ACCESSIBILITY ASSESSMENT

ADA TITLE II ASSESSMENT

Owens Road
1100 Owens Road
Oxen Hill, Maryland 20745

145366.21R000-006.160

Map for Barrier ID: AX239962

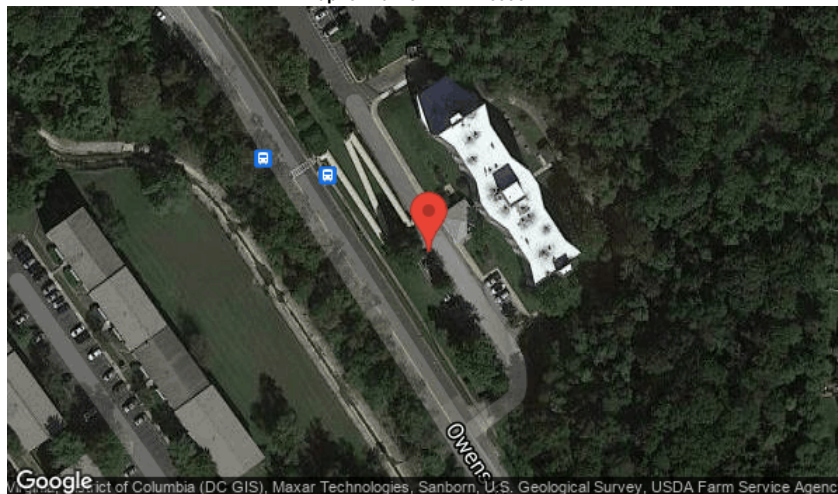
Assembly	Exterior Access Route
Type	Stairs
ADA Standard	505
Barrier Detail	Handrails are not compliant.
Location Description	Stairs from Parking to Main Entrance
Observed	May 20, 2021 by Ouraccessibleworld@gmail.com

Handrails: Install compliant handrails on both sides of the stairway. Inside handrails on switchback or dogleg stairs shall be continuous between runs. Top of gripping surfaces of handrails shall be 34" minimum and 38" maximum vertically above stair nosings. Handrails shall be at a consistent height above ramp surfaces. Clearance between handrail gripping surfaces and adjacent surfaces shall be 1-1/2" minimum. Handrail gripping surfaces shall be continuous along their length and shall not be obstructed along their tops or sides. The bottoms of handrail gripping surfaces shall not be obstructed for more than 20% of their length. Where provided, horizontal projections shall occur 1-1/2" minimum below the bottom of the handrail gripping surface. [EXCEPTION: The distance between horizontal projections and the bottom of the gripping surface shall be permitted to be reduced by 1/8" for each 1/2" of additional handrail perimeter dimension that exceeds 4".] Handrail gripping surfaces with a circular cross section shall have an outside diameter of 1-1/4" minimum and 2" maximum. Handrail gripping surfaces with a non-circular cross section shall have a perimeter dimension of 4" minimum and 6-1/4" maximum, and a cross-section dimension of 2-1/4" maximum. Handrail gripping surfaces and any surfaces adjacent to them shall be free of sharp or abrasive elements and shall have rounded edges. Handrails shall not rotate within their fittings. Handrail gripping surfaces shall extend beyond and in the same direction of stair flights. [EXCEPTIONS: 1. Extensions shall not be required for continuous handrails at the inside turn of switchback or dogleg ramps AND 3. In alterations, full extensions of handrails shall not be required where such extensions would be hazardous due to plan configuration.] At the top of a stair flight, handrails shall extend horizontally above the landing for 12" minimum beginning directly above the first riser nosing. At the bottom of a stair flight, handrails shall extend at the slope of the stair flight for a horizontal distance at least equal to one tread depth beyond the last riser nosing. Extensions shall return to a wall, guard, or the landing surface, or shall be continuous to the handrail of an adjacent stair flight. Removal of this barrier is required if the stairs are part of the required accessible means of egress from the accessible space, per emergency egress plans approved by the administering local authority. [ADVISORY: It is advisable, but not required, to provide a handrail at a height designed for children. When children are the principal users in a building or facility (e.g., elementary schools), a second set of handrails at an appropriate height can assist them and aid in preventing accidents. A maximum height of 28" measured to the top of the gripping surface from the ramp surface or stair nosing is recommended for handrails designed for children. Sufficient vertical clearance between upper and lower handrails, 9" minimum, should be provided to help prevent entrapment.]

Photos for Barrier ID: AX239972

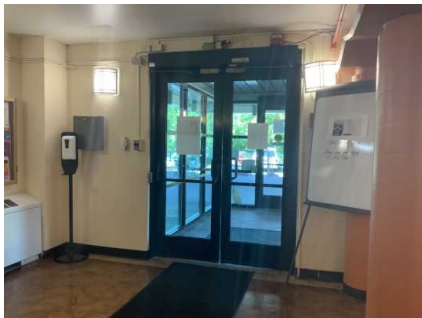
Assembly	Interior Access Route
Type	Signage
ADA Standard	216.4, 703.1, 703.4
Barrier Detail	Means of egress signage is not provided.
Location Description	Lobby
Observed	May 20, 2021 by Ouraccessibleworld@gmail.com
Site Conditions	Means of egress signage with tactile characters is not provided at the exit.

Provide compliant means of egress signage at each exit passageway, exit discharge, and exit stairway. Signs at designated egress passageways, stairways, exit doors and areas of refuge shall include tactile signage. Signs shall be installed alongside the door at the latch side. [EXCEPTION: Signs with tactile characters shall be permitted on the push side of doors with closers and without hold-open devices.] Where a tactile sign is provided at double doors with one active leaf, the sign shall be located on the inactive leaf. Where a tactile sign is provided at double doors with two active leaves, the sign shall be located to the right of the right hand door. Where there is no wall space at the latch side of a single door or at the right side of double doors, sign shall be located on the nearest adjacent wall. Where both visual and tactile characters are required, either one sign with both visual and tactile characters, or two separate signs, one with visual, and one with tactile characters, shall be provided. Signs containing tactile characters shall be located so that clear floor space of 18" minimum by 18" minimum, centered on the tactile characters, is provided beyond the arc of any door swing between the closed position and 45 degrees open. Raised characters shall be compliant and shall be duplicated in Braille. Raised characters shall be as follows- Depth: Raised characters shall be 1/32" minimum above their background. Case: Characters shall be uppercase. Style: Characters shall be sans serif. Characters shall not be italic, oblique, script, highly decorative, or of other unusual forms. Character Proportions: Characters shall be selected from fonts where the width of the uppercase letter "O" is 55% minimum and 110% maximum of the height of the uppercase letter "I". Character Height: Character height measured vertically from the baseline of the character shall be 5/8" minimum and 2" maximum based on the height of the uppercase letter "I". [EXCEPTION: Where separate raised and visual characters with the same information are provided, raised character height shall be permitted to be 1/2" minimum.]

Photos for Barrier ID: AX239977

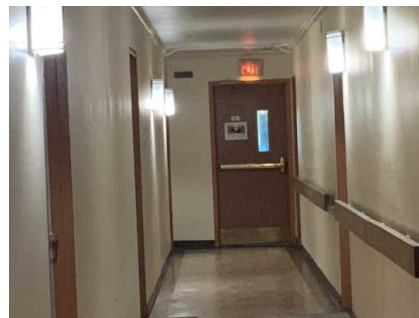
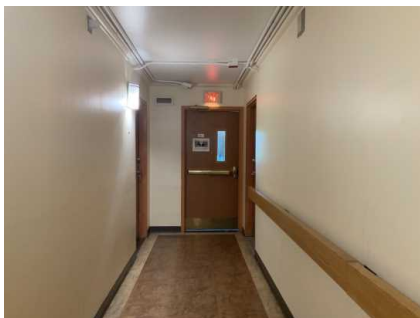
Assembly	Interior Access Route
Type	Signage
ADA Standard	216.4, 703.1, 703.4
Barrier Detail	Means of egress signage is not provided.
Location Description	Throughout Building
Observed	May 20, 2021 by Ouraccessibleworld@gmail.com
Site Conditions	Means of egress signage with tactile characters is not provided at the exits.

Provide compliant means of egress signage at each exit passageway, exit discharge, and exit stairway. Signs at designated egress passageways, stairways, exit doors and areas of refuge shall include tactile signage. Signs shall be installed alongside the door at the latch side. [EXCEPTION: Signs with tactile characters shall be permitted on the push side of doors with closers and without hold-open devices.] Where a tactile sign is provided at double doors with one active leaf, the sign shall be located on the inactive leaf. Where a tactile sign is provided at double doors with two active leaves, the sign shall be located to the right of the right hand door. Where there is no wall space at the latch side of a single door or at the right side of double doors, sign shall be located on the nearest adjacent wall. Where both visual and tactile characters are required, either one sign with both visual and tactile characters, or two separate signs, one with visual, and one with tactile characters, shall be provided. Signs containing tactile characters shall be located so that clear floor space of 18" minimum by 18" minimum, centered on the tactile characters, is provided beyond the arc of any door swing between the closed position and 45 degrees open. Raised characters shall be compliant and shall be duplicated in Braille. Raised characters shall be as follows- Depth: Raised characters shall be 1/32" minimum above their background. Case: Characters shall be uppercase. Style: Characters shall be sans serif. Characters shall not be italic, oblique, script, highly decorative, or of other unusual forms. Character Proportions: Characters shall be selected from fonts where the width of the uppercase letter "O" is 55% minimum and 110% maximum of the height of the uppercase letter "I". Character Height: Character height measured vertically from the baseline of the character shall be 5/8" minimum and 2" maximum based on the height of the uppercase letter "I". [EXCEPTION: Where separate raised and visual characters with the same information are provided, raised character height shall be permitted to be 1/2" minimum.]
